STATE OF HAWAII DEPARTMENT OF TRANSPORTATION HIGHWAYS DIVISION MECHANICALLY STABILIZED EARTH RETAINING WALL (MSERW) TYPICAL SECTION AND DETAILS KAHKILI HIGHWAY WIDENING Likelike Hwy. to Vicinity of Haiku Road F.A. PROJECT NO. NH-083-1(26) SCALE: AS NOTED DATE: APRIL 1994 SHEET No. W1 OF W21 SHEETS	
--	--

AS-BUILT ADD. 114

KAHEKILI HIGHWAY WIDENING
Likelike Hwy. to Vicinity of Haiku Road
F.A. PROJECT NO. NH-083-1(26)

REVISION TO SOUND WALL
SECTION F AT RC WALL NO. 17

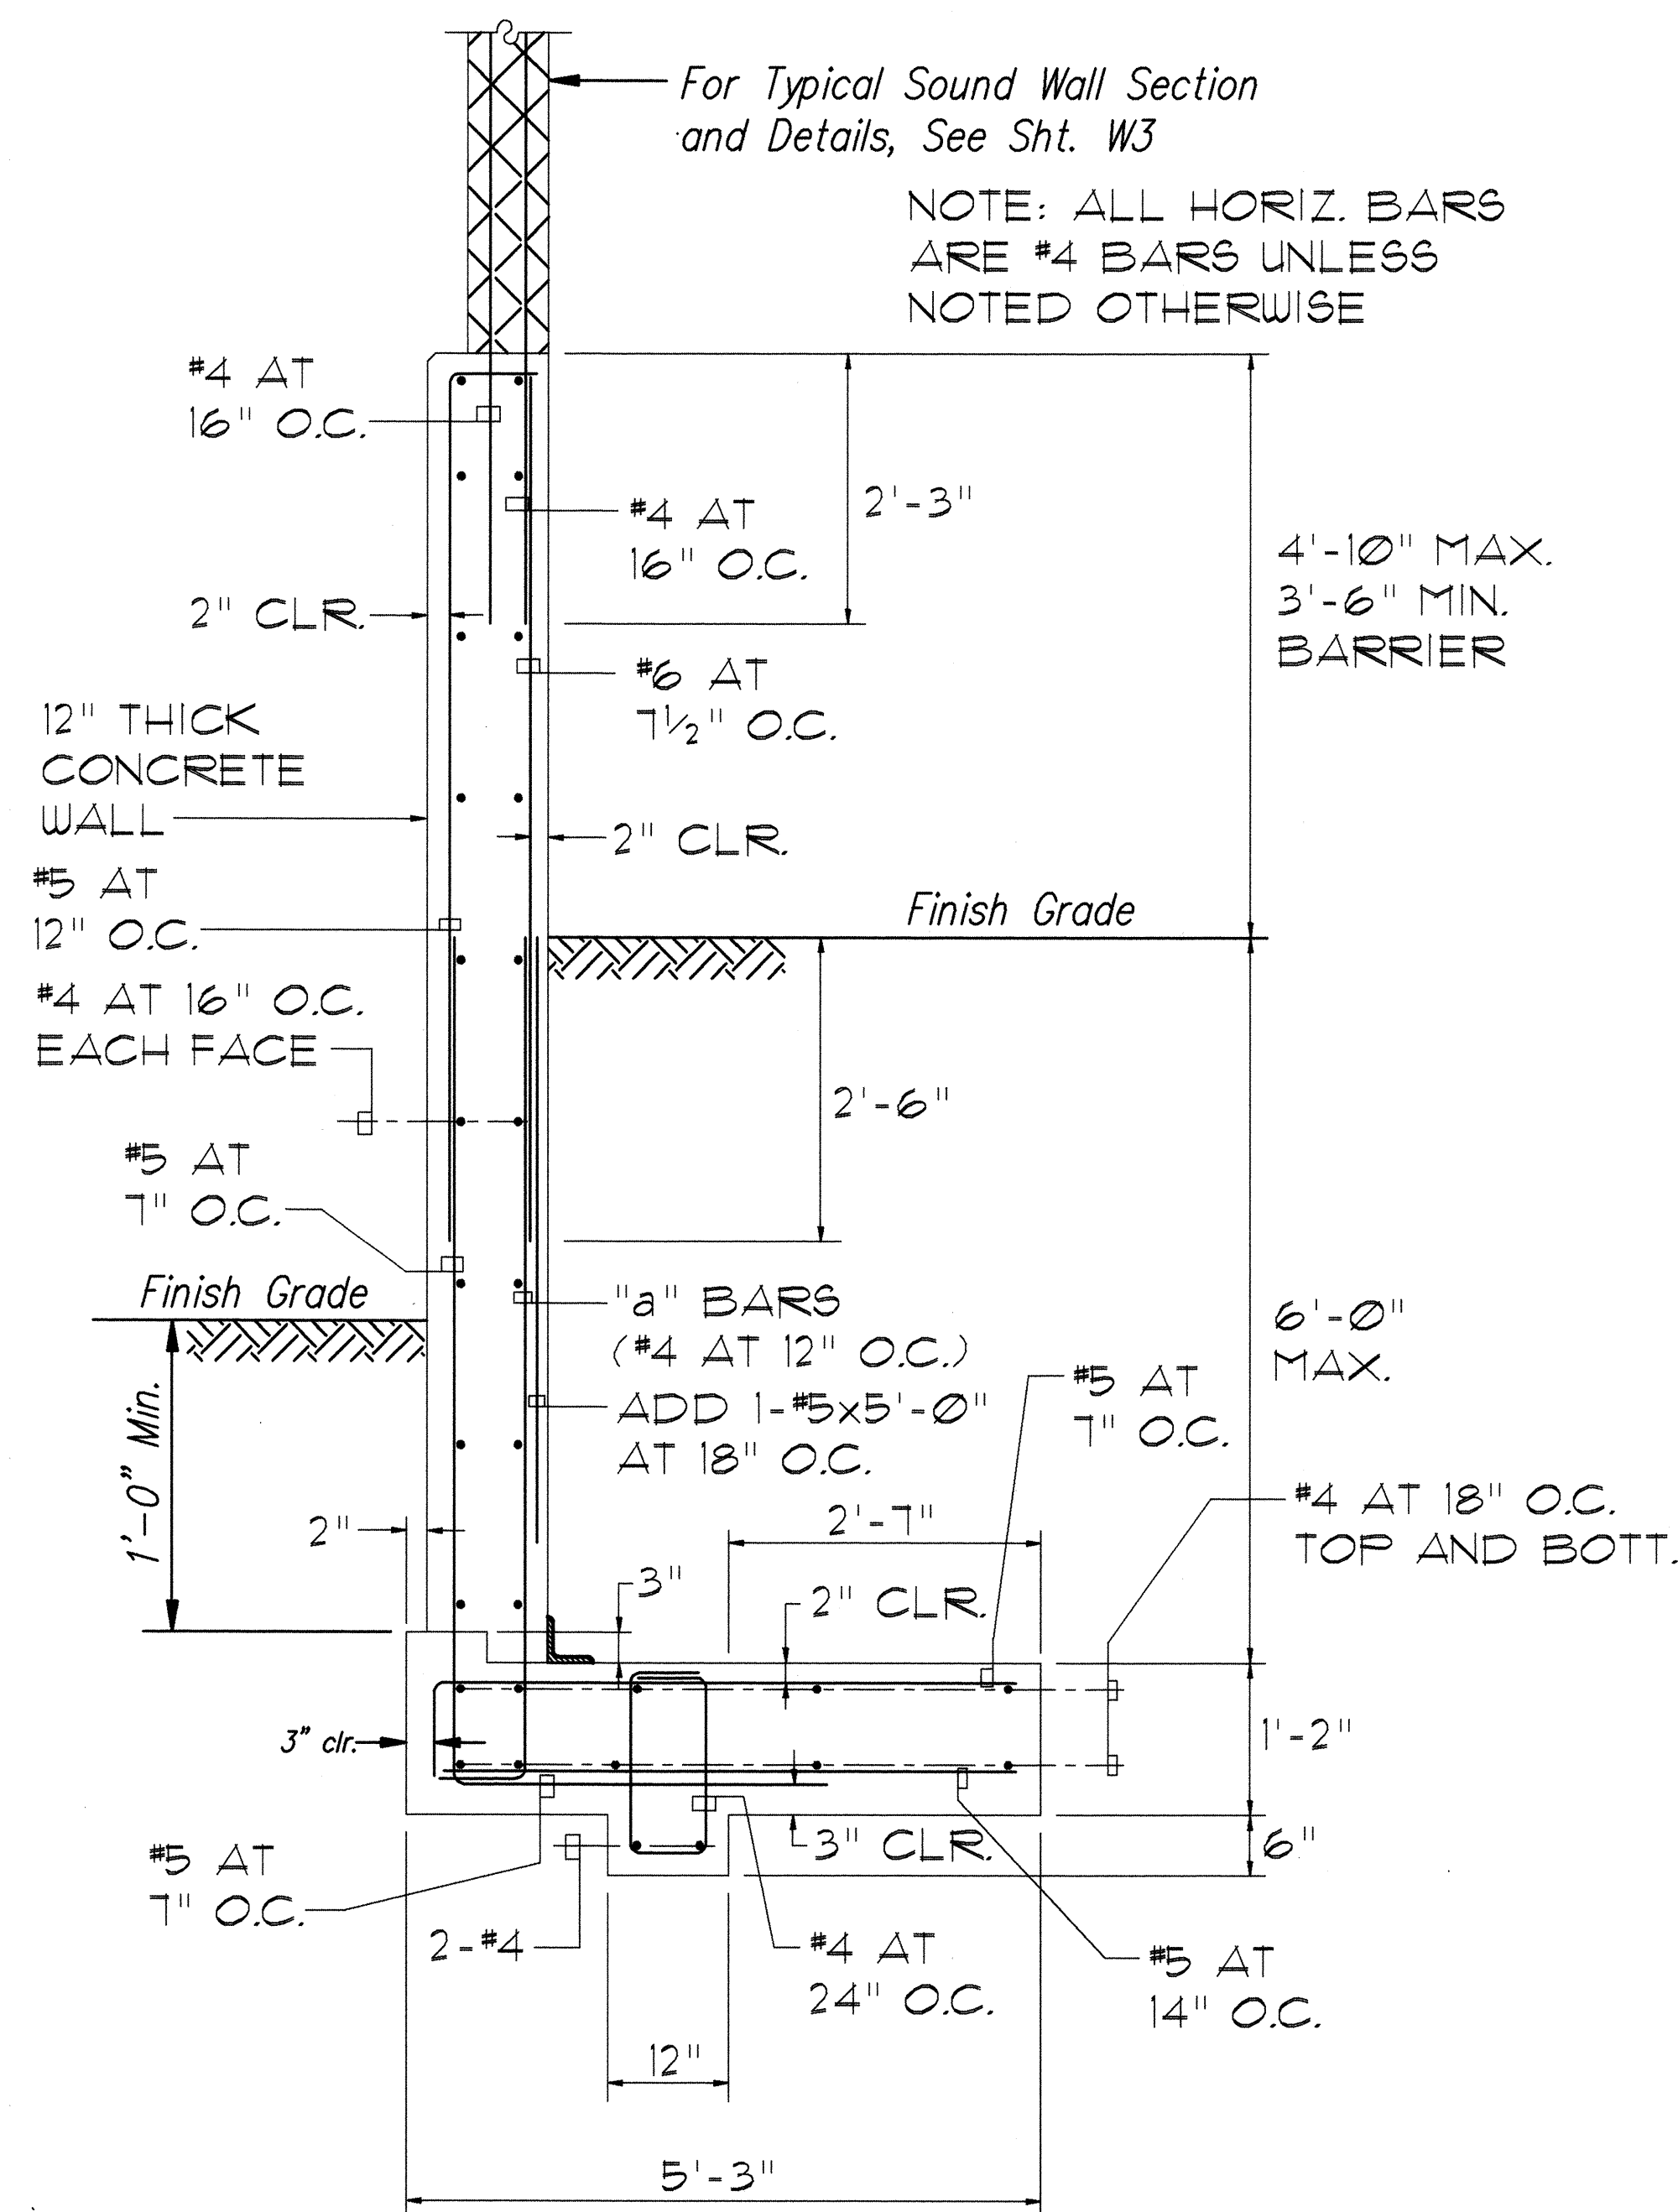
THIS SECTION SUPERCEDES SIMILARLY
TITLED SECTION ON SHEET W10 (ADD123)

SOUND WALL SECTION "E"

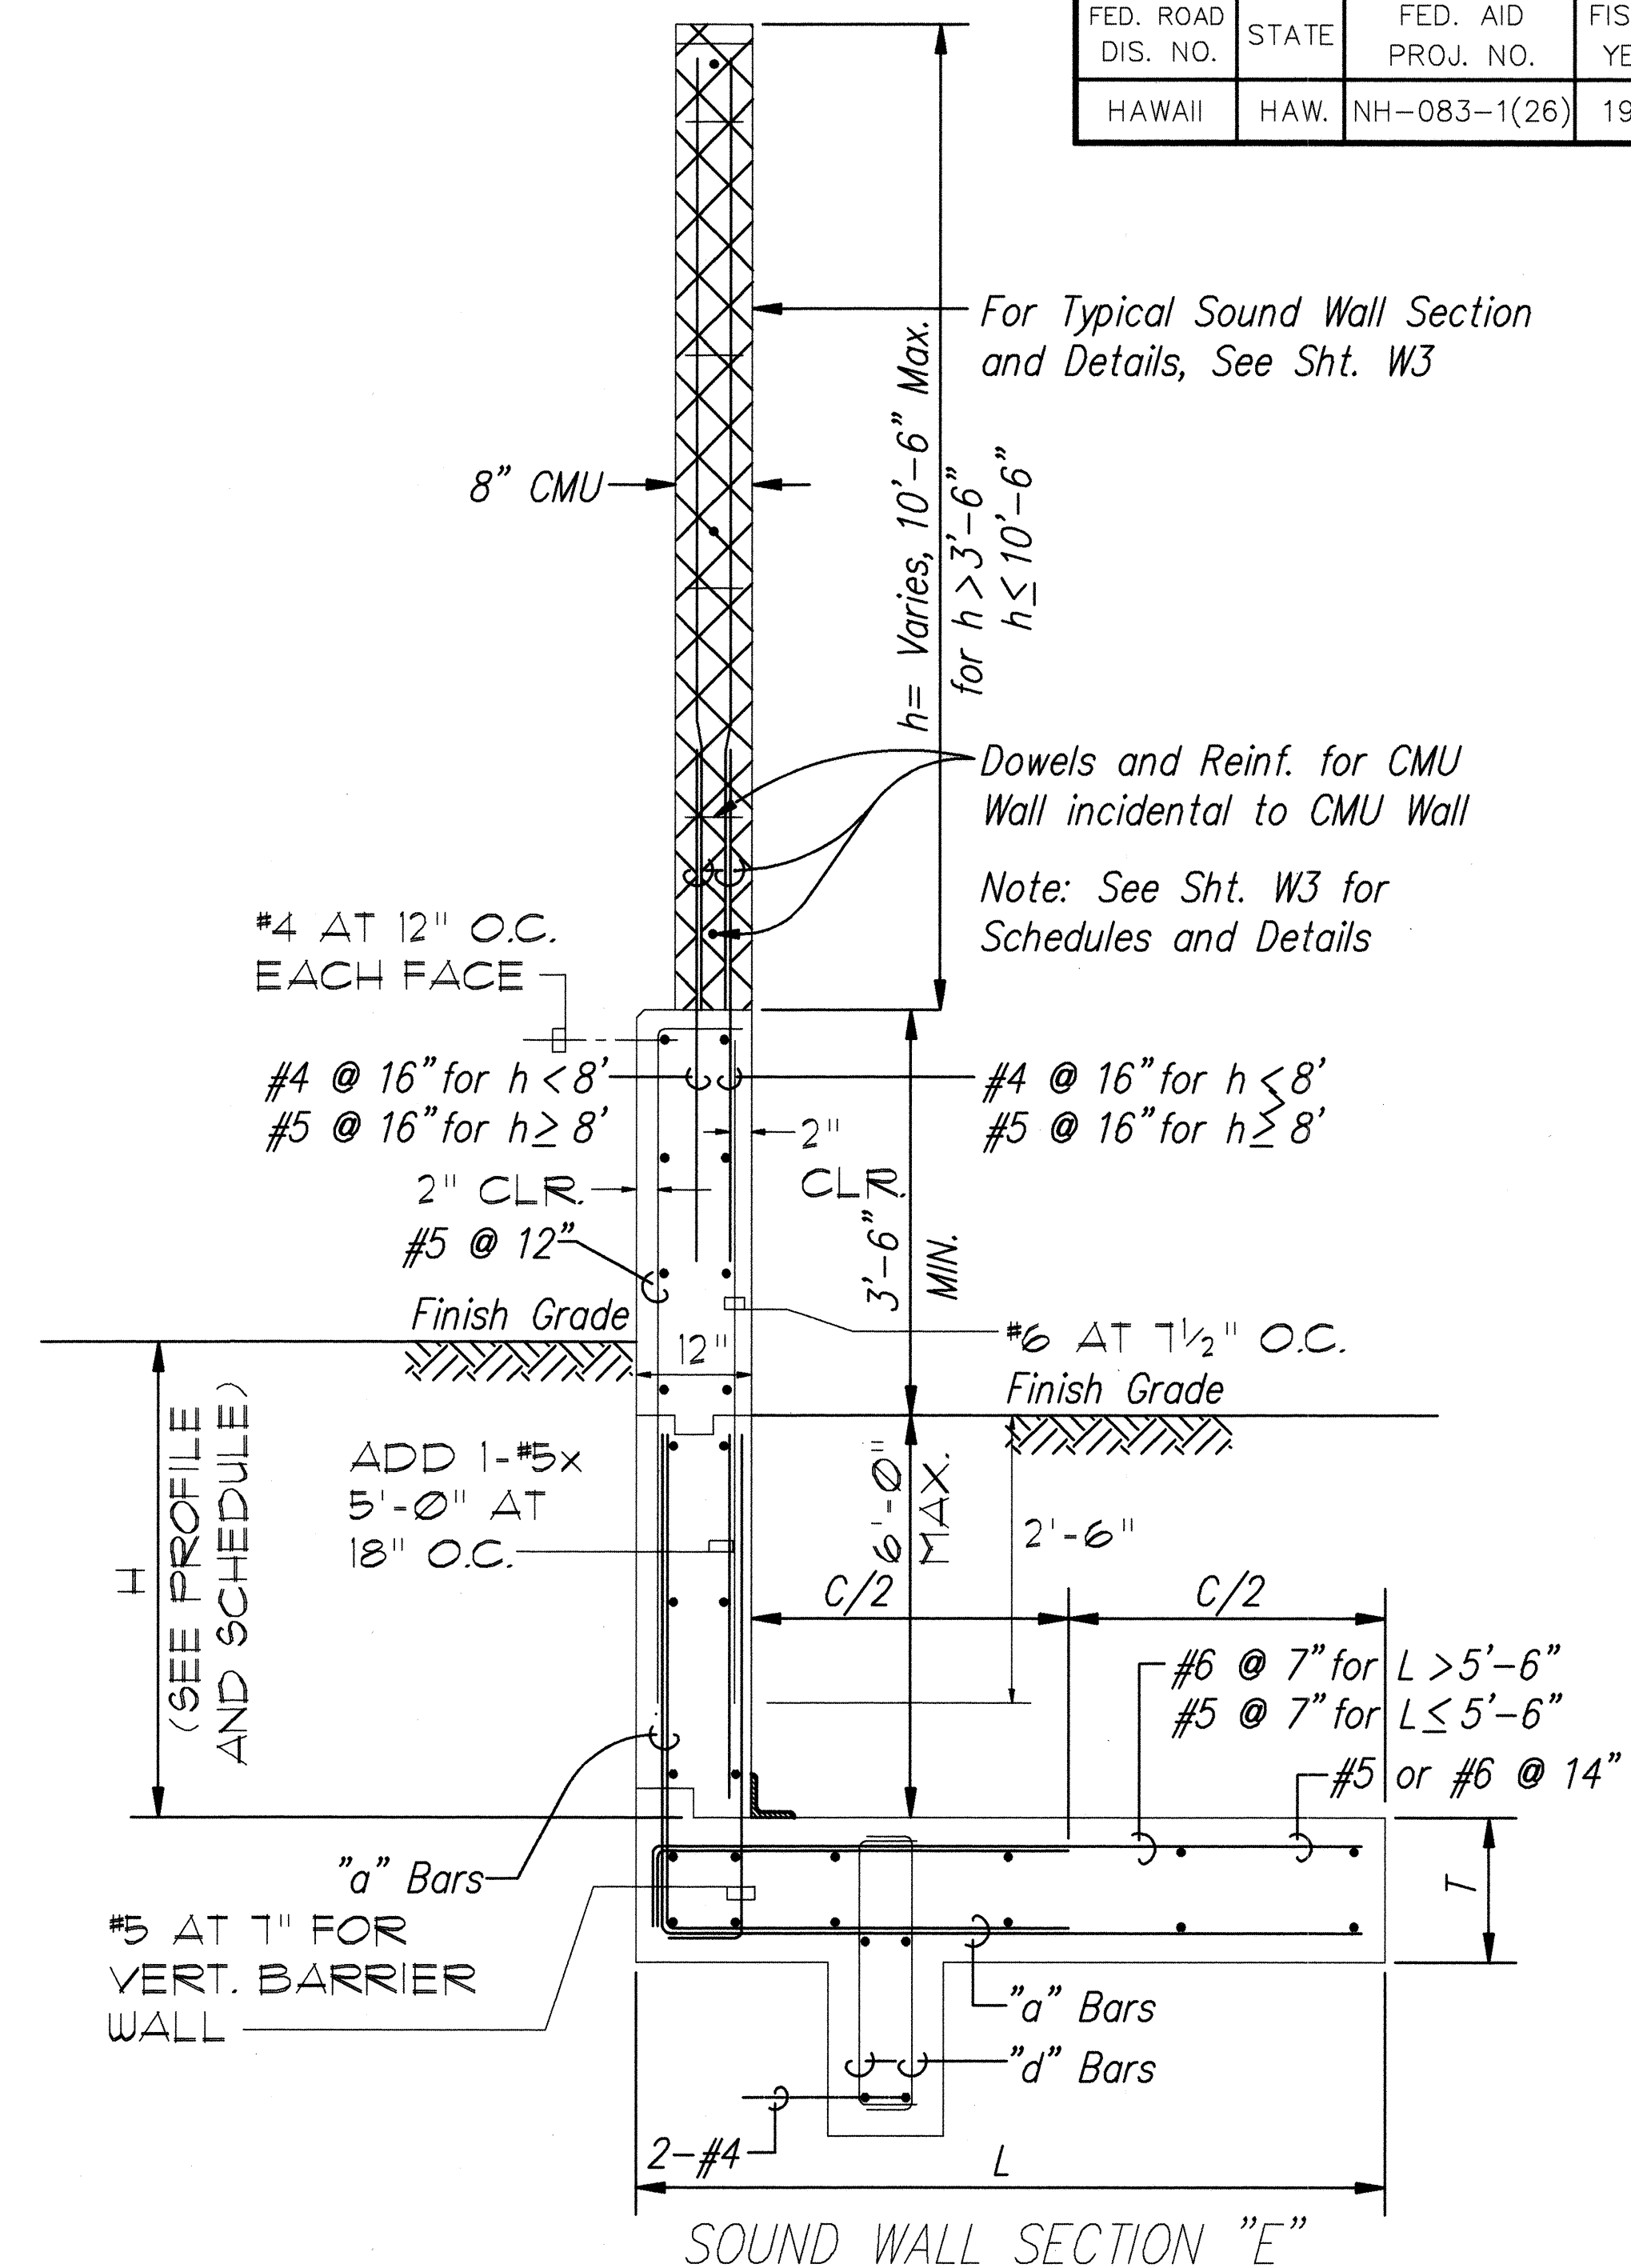
THIS SECTION SUPERCEDES SIMILARLY
TITLED SECTION ON SHEET W17 (ADD130)
